**CITY OF BLOOMINGTON**

**CITY OF BLOOMINGTON  
PLAN COMMISSION  
August 10, 2015 @ 5:30 p.m.**

**BLOOMINGTON PLAN COMMISSION  
STAFF REPORT – SECOND HEARING  
Location: 2300 S. Walnut Street**

**CASE #: SP-15-15  
DATE: August 10, 2015**

SP-15-15  
Petitioner Statement

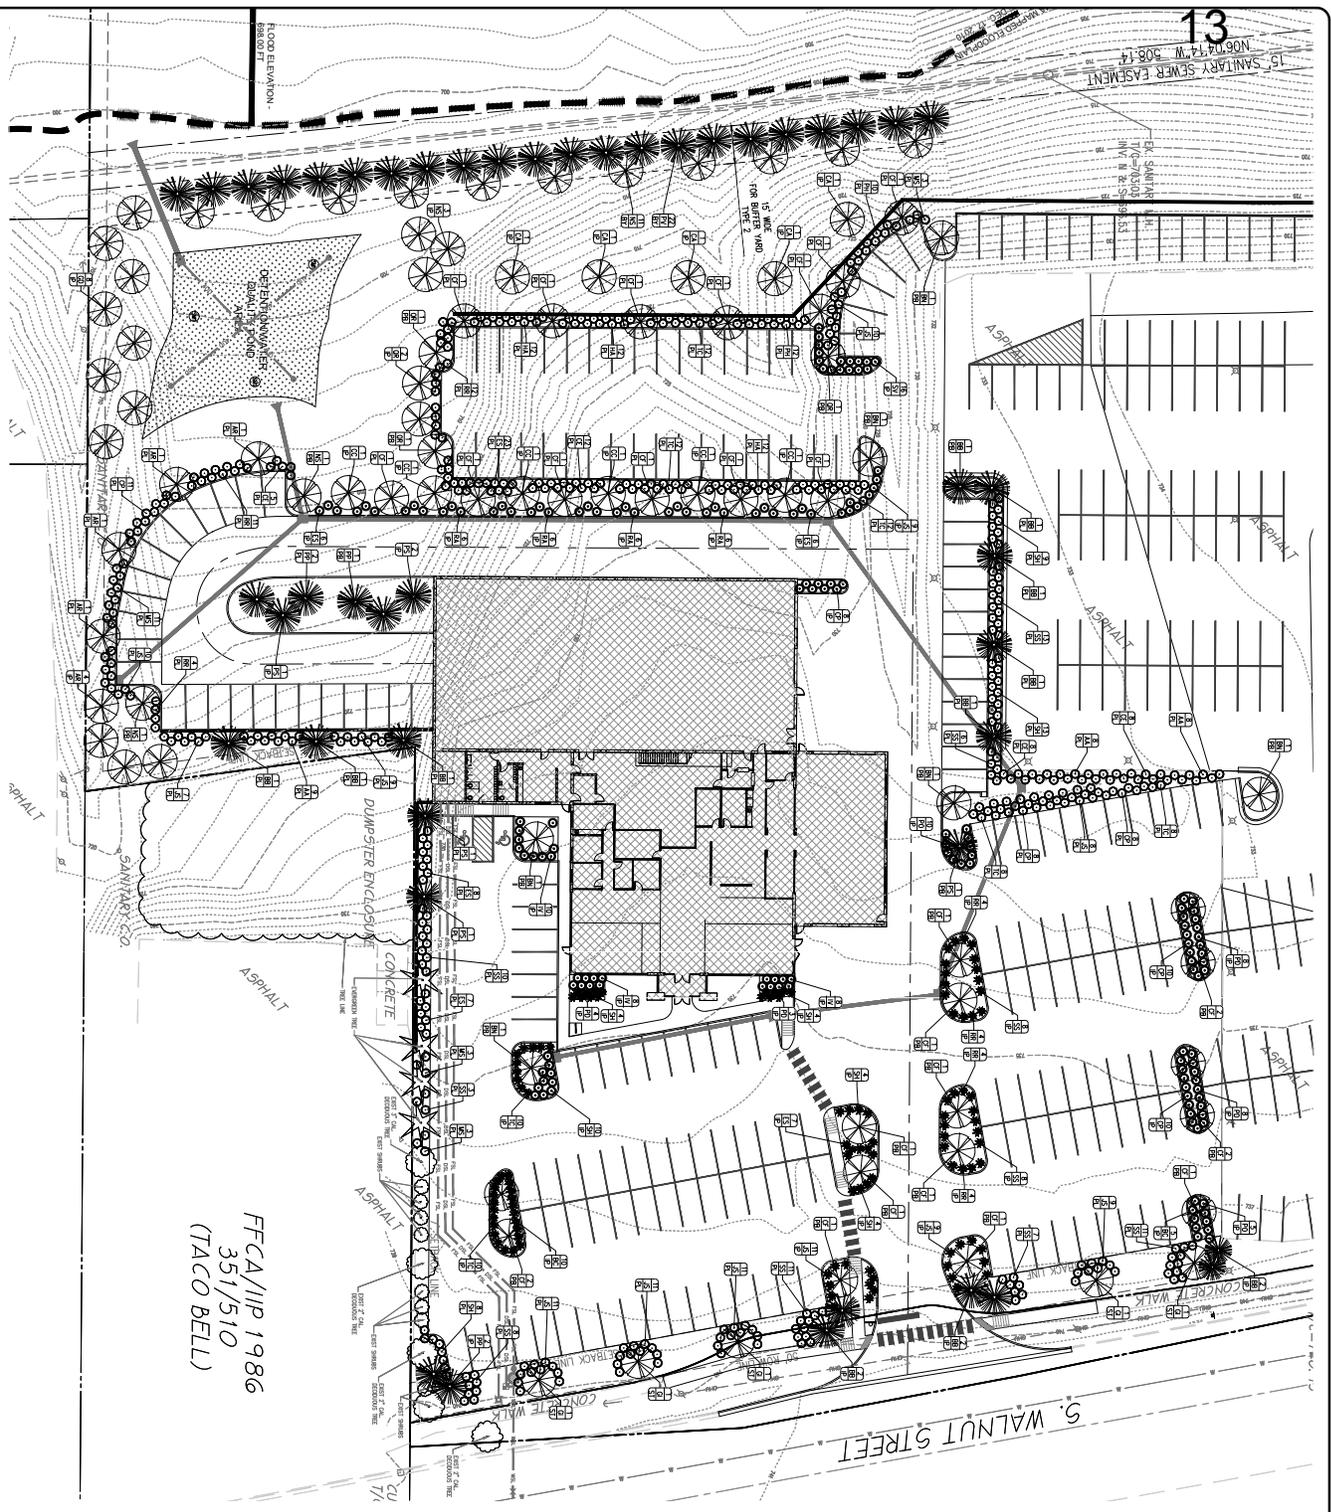
**Architecture/Design:** The building will have large glass windows along the majority of the front with EIFS and painted precast concrete on the main building face, which are both permitted materials. As mentioned previously, there have been new architectural elements added to the building to meet code requirements that include new windows, an awning, and building modulation.

Also attached are the revised elevations and rendering of the Chrysler Building. The Architect has added windows, metal canopy and wall projections to the area facing Walnut Street that did not meet the UDO requirements.

**SP-15-15**  
**Landscape Plan**

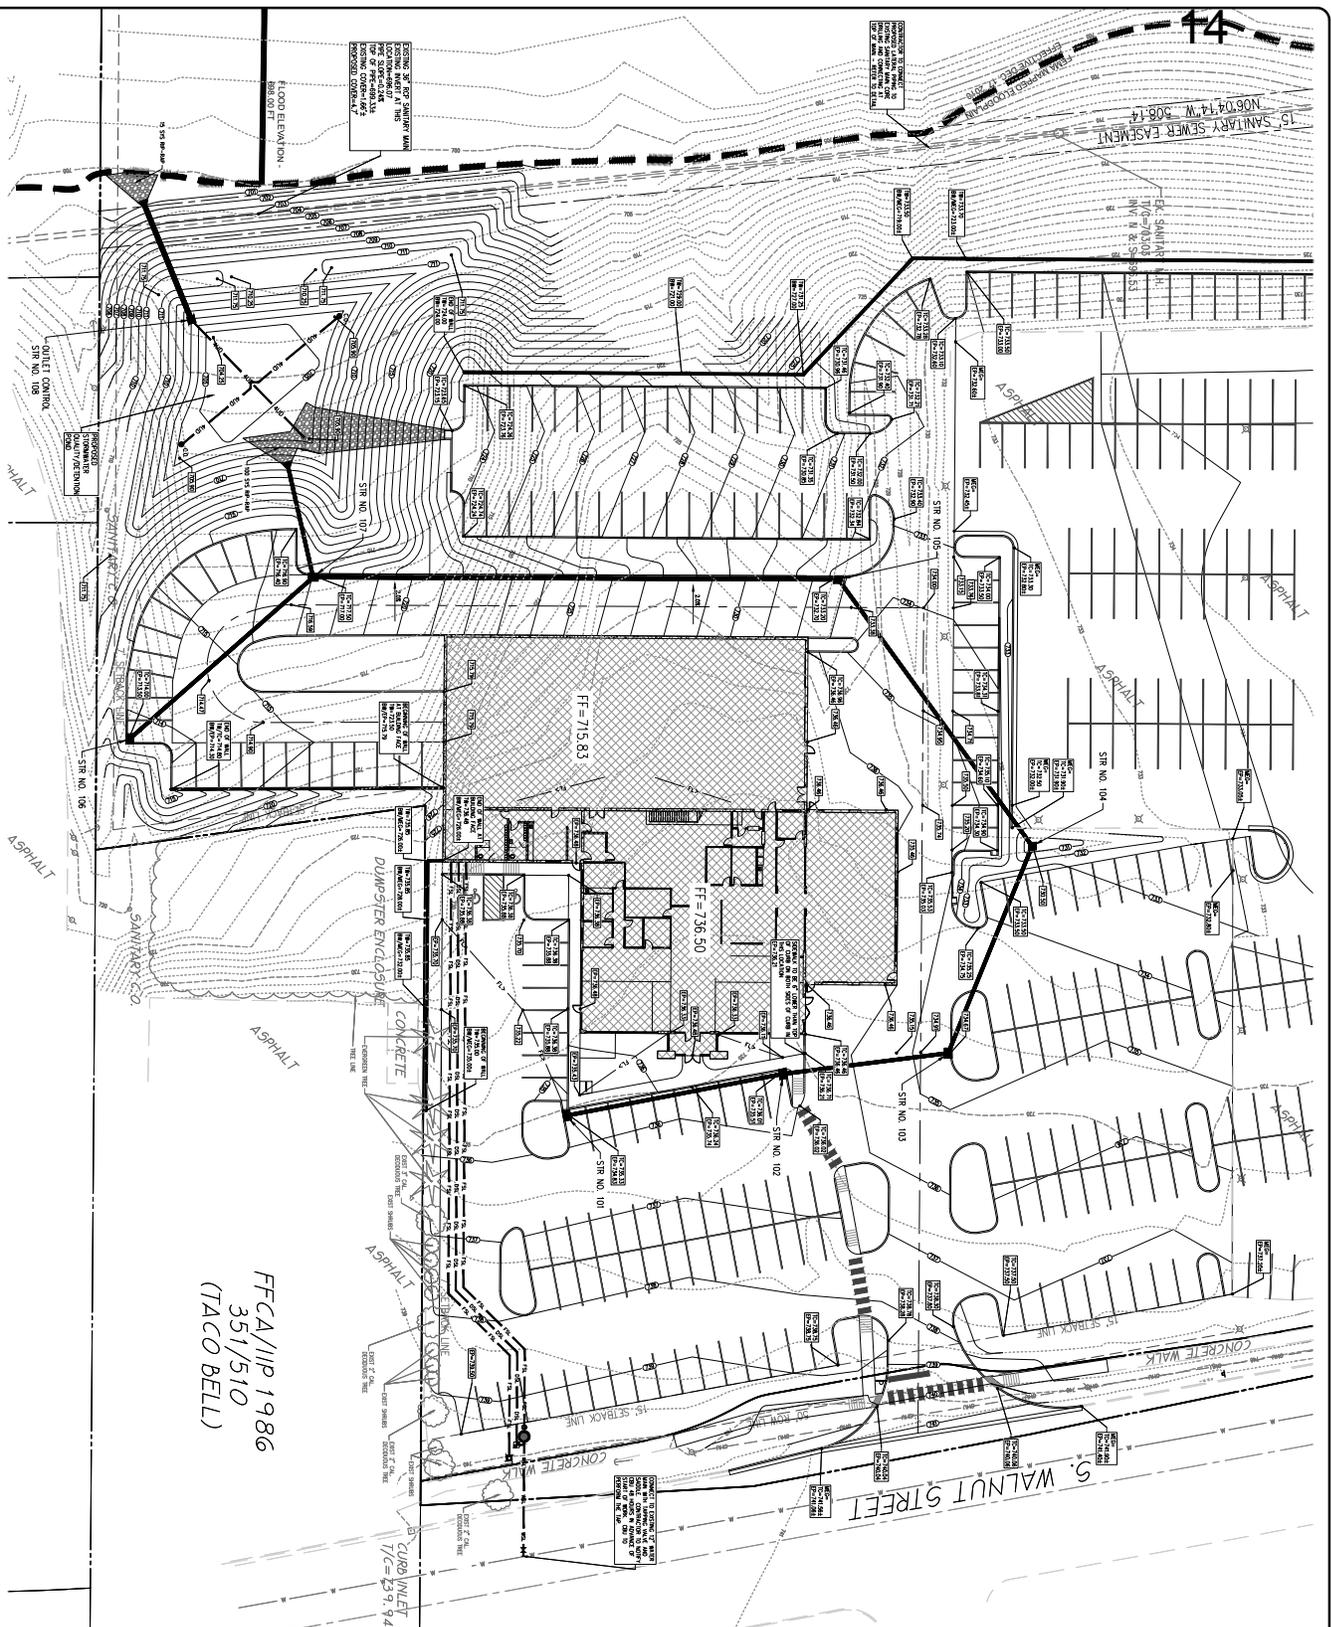
The EC has no objection to the variance of smaller trees in the parking lot islands. However, the submitted Landscape Plan still is deficient, thus the EC recommends the Petitioner continue to work with the Planning and Transportation staff to satisfy the requirements of the UDO.

The Landscape Plans shows deficiencies such as the following.

1. Not enough street trees;
2. Missing Erosion Control Plan, which is necessary to complete the landscape review;
3. Using short perennial plants for parking lot perimeter instead of the required shrubs.

1. The Petitioner shall revise the Landscape Plan to meet UDO regulations at a minimum.

**Staff response:** Staff will continue to work with the petitioner to revise the proposed landscape plan and incorporate the Environmental Commission's recommendations.

**PUD-16-15  
Site Plan**

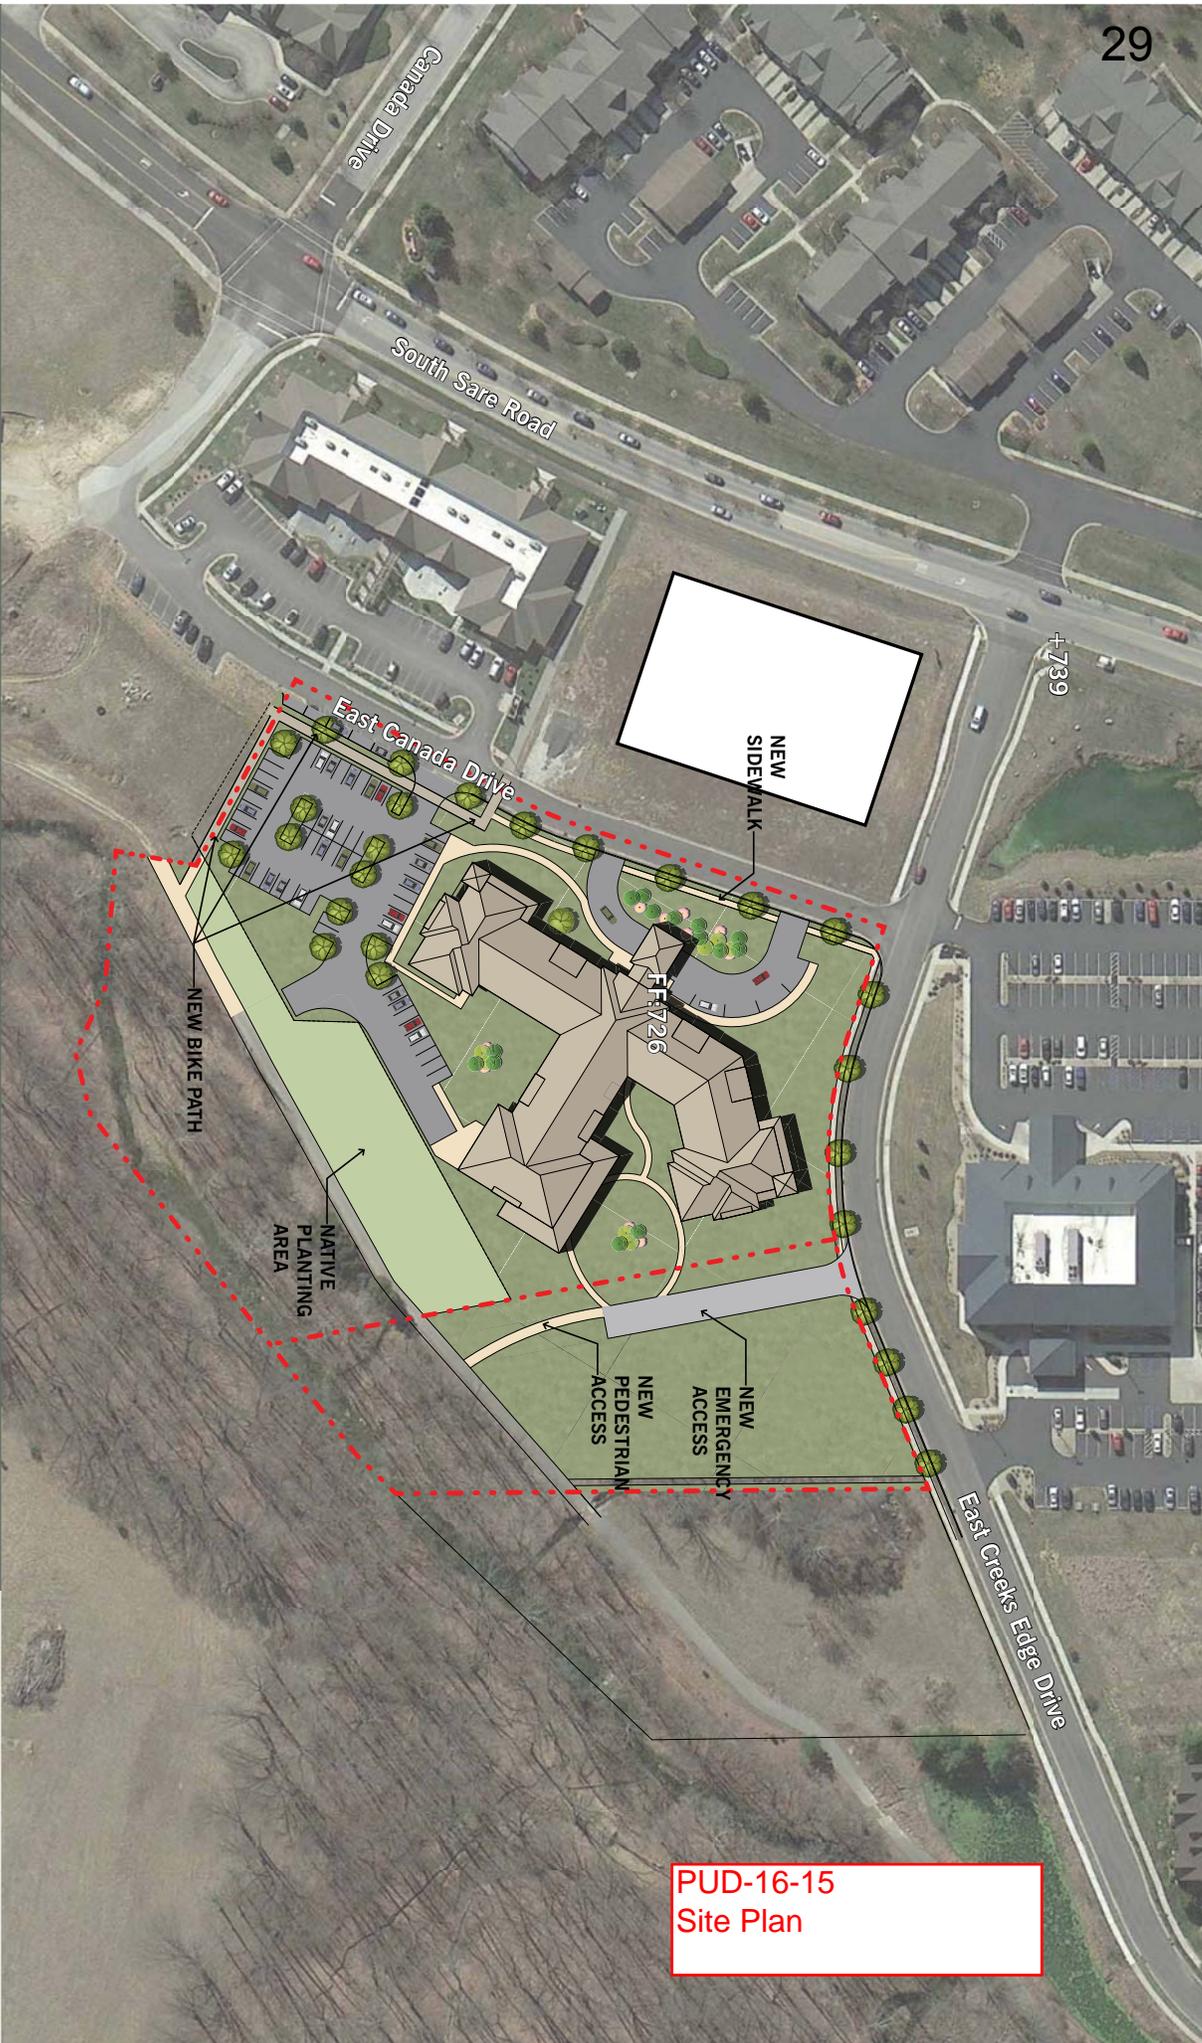
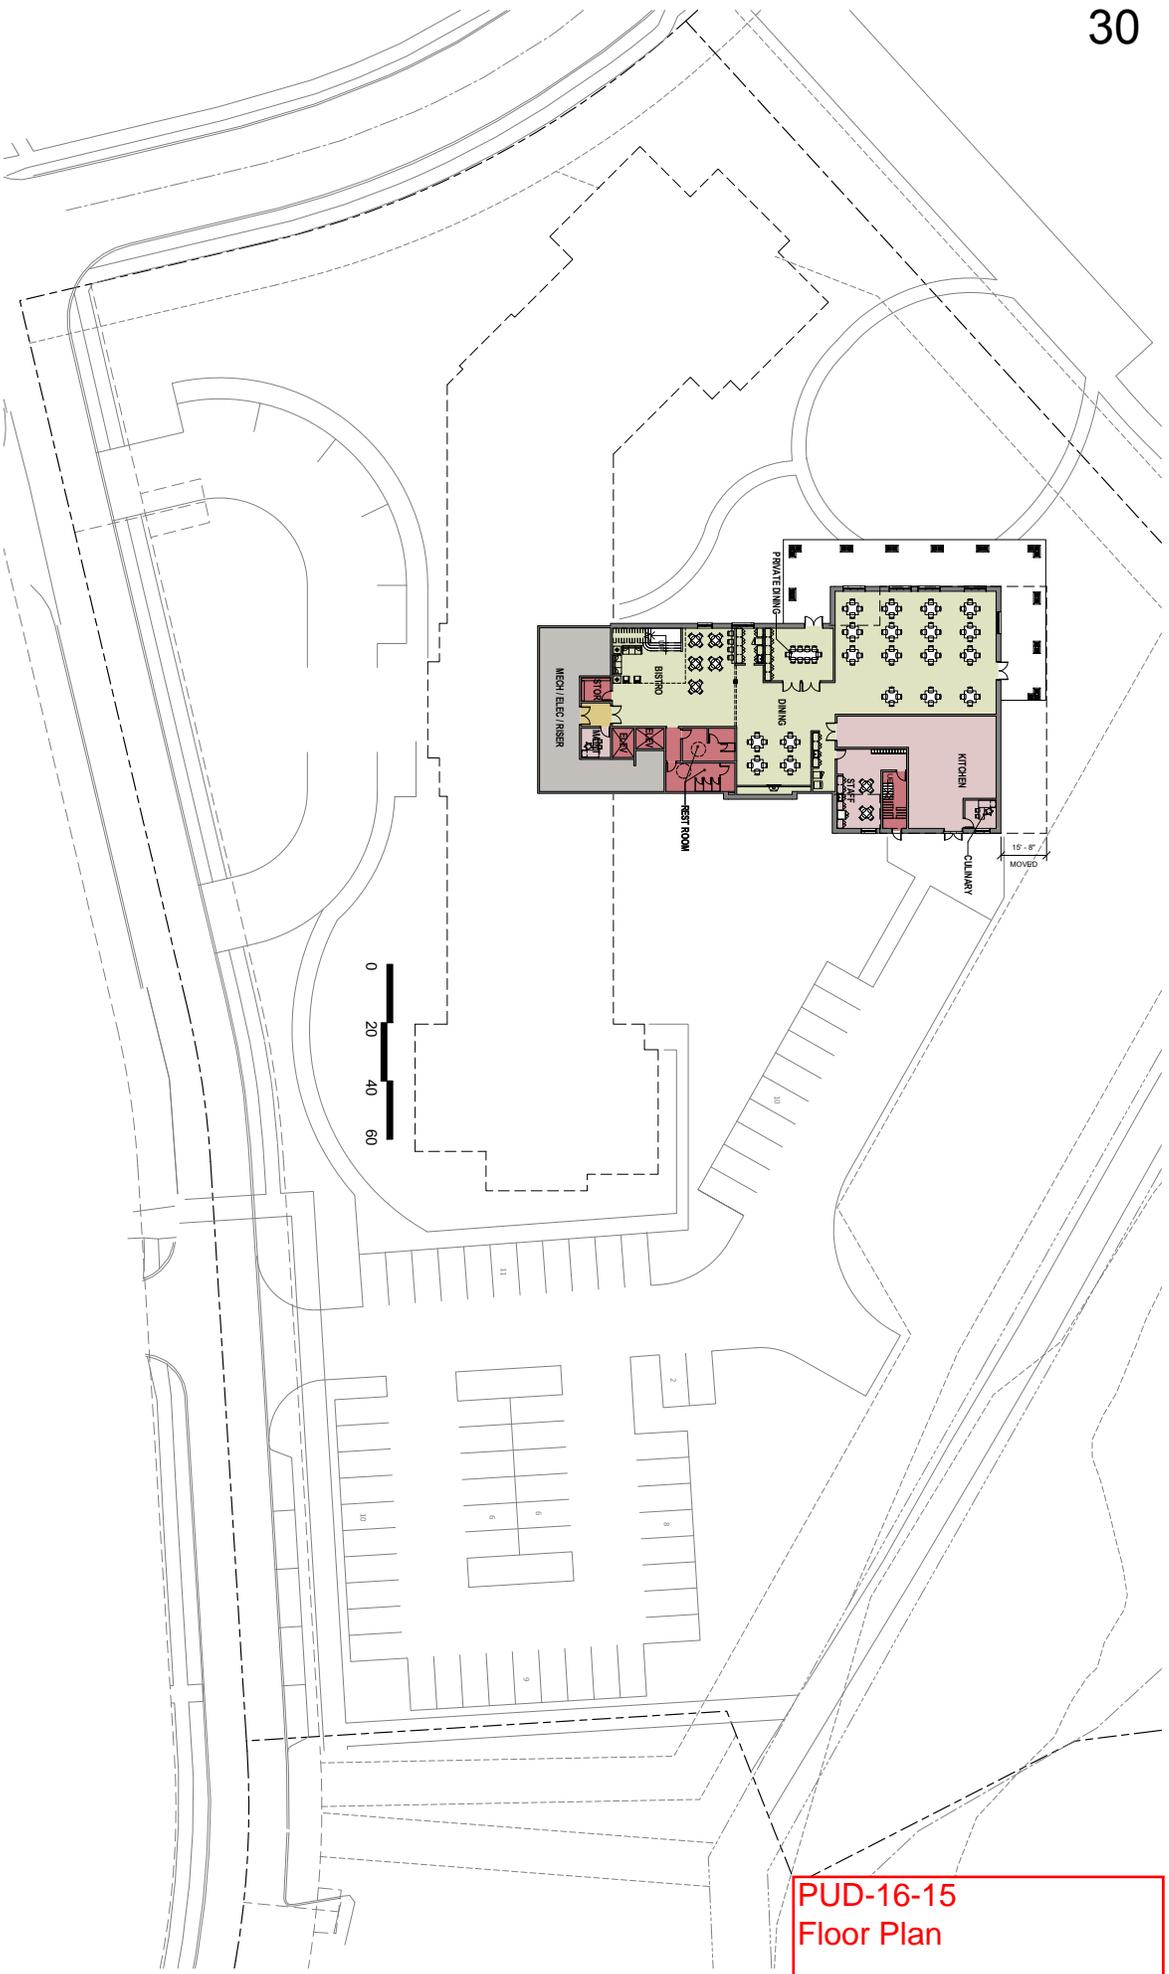
**CHANGES SINCE FIRST HEARING:** The Plan Commission heard this case at the July 13, 2015 hearing. At that hearing, the Plan Commission expressed comments regarding architecture and requested that the limestone columns along the front be extended to the top of the façade, more information was requested regarding the use of environmentally friendly construction practices and interior products, the creation of an outdoor recreation area was suggested, and the petitioner was urged to incorporate as many of the environmental commission's comments as possible.

**Access:** There is a circle drive shown along the private internal drive to provide access to the front and to facilitate drop-offs. There is a covered awning shown that extends over this driveway and entrance. There is another drivecut shown along the internal driveway for the parking area located in the rear of the property. A sidewalk and street trees were required along the west side of the internal driveway with the previous petitions for the multi-tenant building and the daycare facility, and would be required along the east side of the internal drive as well with this petition. A secondary emergency access drive has been shown along the east side of Lot #5 to provide an additional access point for emergency services.

- We have been able to increase the total number of parking spaces to 67 from 62. As part of the installation of the new sidewalk/bike path along E. Canada Drive, we will likely need to remove the 9 existing horizontal parking spaces utilized by Lot 2 via the Parking Easement. We are currently planning to replace these spaces with 5 new parallel parking spots. We have shared this proposed change with the owner's of Lot 2. If necessary, we will work with them to amend the parking easement to allow for some form of a shared parking arrangement to exist between the two sites.

- We are proposing adding a bike path that will connect to the property at E. Canada Drive and will connect to the Jackson Creek Trail path via access we will provide along the boundaries of Lot 4 and Lot 3. We have redirected the bike path along the property line to minimize conflicts between public bicyclists and private parking area pedestrians accessing our facility. By turning the path to the south and avoiding long straight-a-ways, bicyclists will necessarily have to slow down through this area. These precautions will reduce the opportunity for accidents to occur.

- We are proposing adding a combination public walking path and emergency access road within Lot 5. This path/road will provide a sidewalk connection to E. Creeks Edge Drive and the Jackson Creek Trail. The multi-purpose path will be clearly distinguished from the sidewalk along E. Canada Drive, per the PUD requirements. Access will be limited to pedestrians and emergency vehicles. Access by bicycles and non-emergency motorized vehicles will be prohibited. Beyond the point where emergency vehicle access is needed we are considering narrowing the multi-purpose path and/or utilizing bollards to limit access to Jackson Creek Trail only to pedestrian traffic.

- We propose a native plant zone for the area East of the parking lot and service drive, extended to the north property line as indicated on the revised site plan. Any plants installed within this area will be Midwest native species.
